Project	IEEE 802.16 Broadband Wireless Access Working Group < http://ieee802.org/16 >
Title	Modified LDPC Matrix providing improved performance
Date Submitted	2004-05-18
Source(s)	Brian Classon, Yufei Blankenship 847-576-5675 Motorola Brian.Classon@Motorola.com
Re:	802.16e D2
Abstract	New LDPC matrix providing improves performance for shortened codes
Purpose	Replace text in previous LDPC proposal: "Draft text for LDPC coding scheme for OFDMA"
Notice	This document has been prepared to assist IEEE 802.16. It is offered as a basis for discussion and is not binding on the contributing individual(s) or organization(s). The material in this document is subject to change in form and content after further study. The contributor(s) reserve(s) the right to add, amend or withdraw material contained herein.
Release	The contributor grants a free, irrevocable license to the IEEE to incorporate material contained in this contribution, and any modifications thereof, in the creation of an IEEE Standards publication; to copyright in the IEEE's name any IEEE Standards publication even though it may include portions of this contribution; and at the IEEE's sole discretion to permit others to reproduce

Figure 1. Block Diagram of one possible encoder for specified LDPC code.

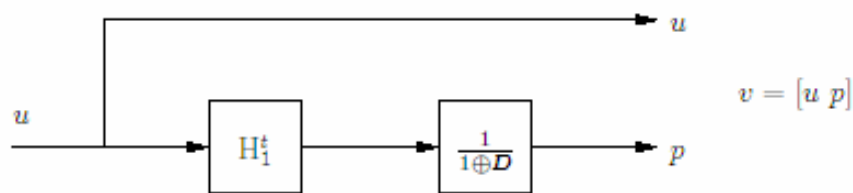
In section 8.4.9.2.4.2 LDPC encoding:

Delete the text:

However, for this code H_2 is simply $f(D) = 1 + D$, and hence H_2^{-t} can be implemented by a differential encoder. One possible encoding process is then

Equation 1

$$v = [u \mid uH_1^t H_2^{-t}] = \left[u \mid uH_1^t \frac{1}{1+D} \right]$$

and is illustrated in Figure 1.

For the described code H_1 is low-density, with a uniform column weight of four.

Replace with:

However, for this code H_2 has a simple deterministic structure, and encoding can be performed recursively. H_2 is composed of two parts. The weight 3 first column $\mathbf{h} = [h_0, h_1, \dots, h_{m-2}, h_{m-1}]^T = [1 \ 0 \ 0 \ 0 \ 1 \ 0 \ 0 \ 0 \ 1 \ 0 \ \dots \ 0]^T$. The rest of the columns (denoted by the m -by- $(m-1)$ matrix \mathbf{H}'_2 , where $m=n-k$) are weight-2 with maximum of 1 overlap between each other: \mathbf{H}'_2 has matrix elements equal to a 1 for $i=j$ and a 1 for $i=j+1$, and a 0 elsewhere, for row i , column j of \mathbf{H}'_2 , $0 \leq i \leq m-1$, $0 \leq j \leq m-2$.
